SERVICE BULLETIN

SB No. 133 Issue No. 2

TITLE INSPECTION OF FLAP LEVER PIVOT ATTACHING POINT FOR CRACKING

T67A, T67B, T67C Series, T67M, T67M-MkII, T67M200, T67M260 and T67M260-T3A.

FIGURE 1 FLAP OPERATING HANDLE
(ITEMS DELETED FOR CLARITY)

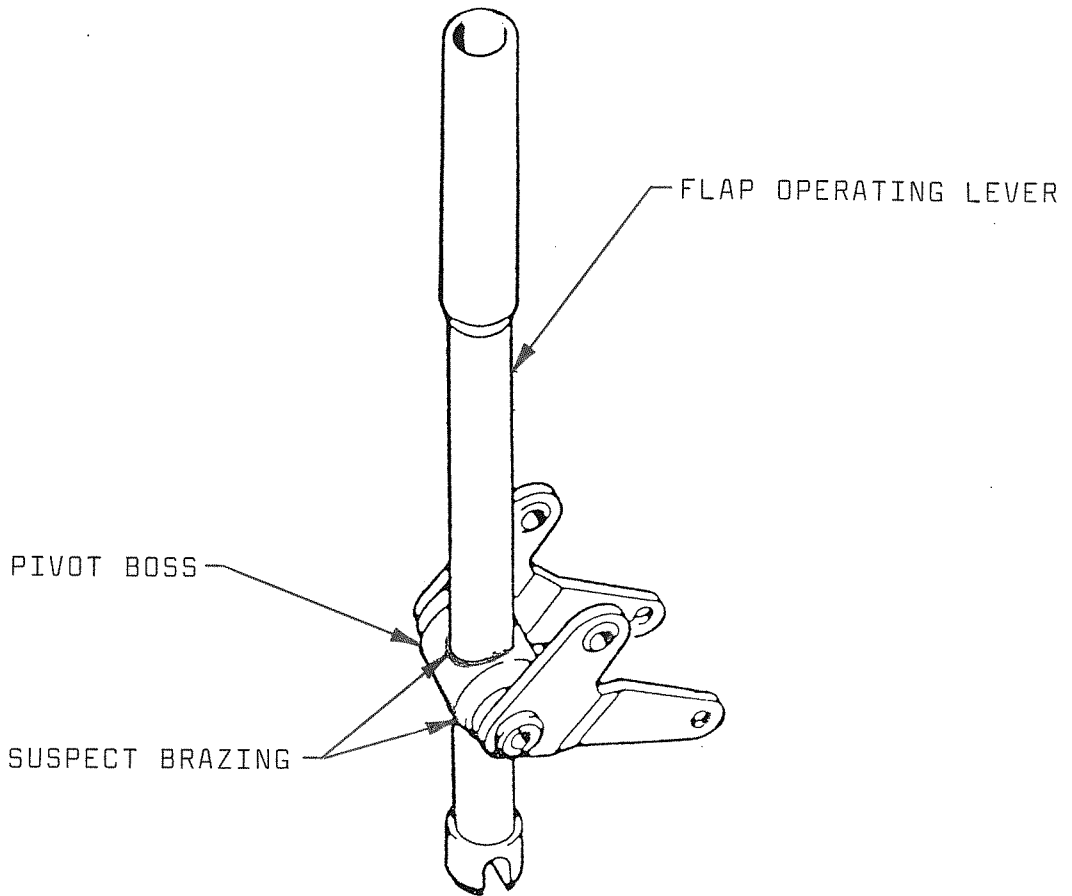
Cases have been reported of cracking in the brazed joints above and below the lever pivot point.

This SB requires an inspection to be carried out on the flap lever pivot boss.

1. Gain access to the flap lever pivot boss.
2. Establish whether flap lever is brazed or welded. If in doubt, remove paint from joint. Welded joint will be the natural metal colour. If welded joint identified, restore finish. Annotate Log Book, "SB 133 complied with". If brazed joint identified, continue as para 3 below.
3. Inspect, using strong light and mirror, all brazing between lever and pivot boss, above and below pivot.
 - i. If no cracking present, certify item as serviceable. Annotate aircraft log book, "Service Bulletin No.133 complied with". Re-inspect at next annual.
 - ii. If brazed joint is found to be cracked, remove flap lever assembly, strip down flap lever completely and replace lever with Part No.T67B-45-262.

4. Return any cracked levers to manufacturer for repair.
5. Report findings, cross referenced to aircraft serial number to Slingsby Aviation.
6. Annotate aircraft Logbook "SB 133 complied with".
